**NUMBER:** 08-006-17

Incorrect Stop Lamp Sensor Installed

2017	(WD)	Dodge Durango
2017	(WK)	Jeep Grand Cherokee

**Fig. 1 Stop Lamp Sensor**

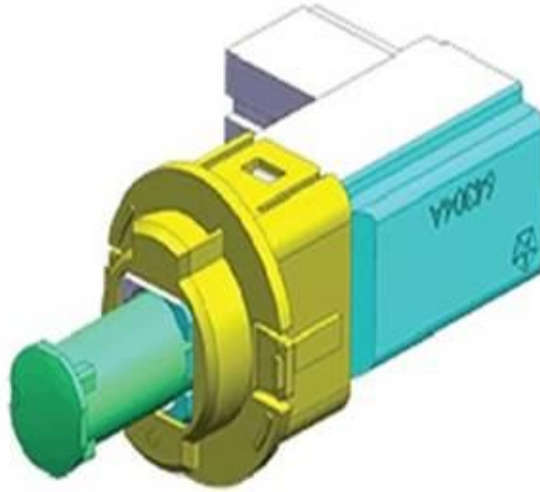
If a customer's VIN is listed in VIP or your RRT VIN list, perform the repair. These vehicles had the incorrect stop lamp sensor installed (Fig. 1).
